UNITED STATES PATENT AND TRADEMARK OFFICE

APPLICATION NO.	FILING DATE	FIRST NAMED INVENTOR	ATTORNEY DOCKET NO.	CONFIRMATION NO.
10/684,684	10/15/2003	Kohei Yamanaka	Q76899	3402

Office Action Summary

DETAILED ACTION

FIG.2

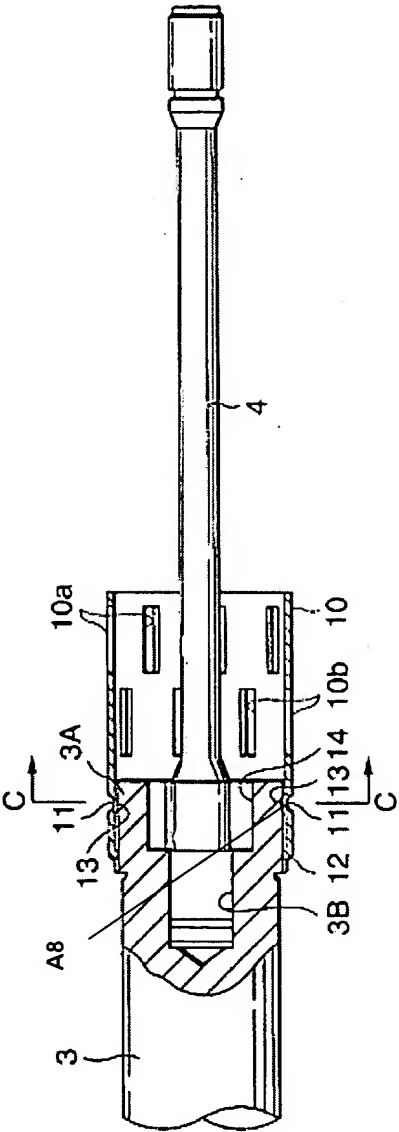
Regarding claim 1, Chikaraishi discloses, in Figures 2 and 5B, a structure comprising a shaft member **3** and a cylindrical member **10**. The shaft member **3** is formed out of a first material. The cylindrical member **10** is formed out of a second material greater in linear expansion coefficient than the first material (col. 1, lines 48-

53). The shaft member **3** has an outer periphery **A2** formed with an axial groove **11** or a circumferential groove **12**. The circumferential groove **12** has a cross-section having opposed faces **A5** substantially parallel to each other. The cylindrical member **10** is fitted to the outer periphery **A2** of the shaft member **3**. A caulked portion **11** is provided to the cylindrical member **10** at a position corresponding to the circumferential groove **12** of the shaft member **3**. The caulked portion **11** has a deformed inner surface **A8** in press contact with the faces **A5** of the circumferential groove **12**.
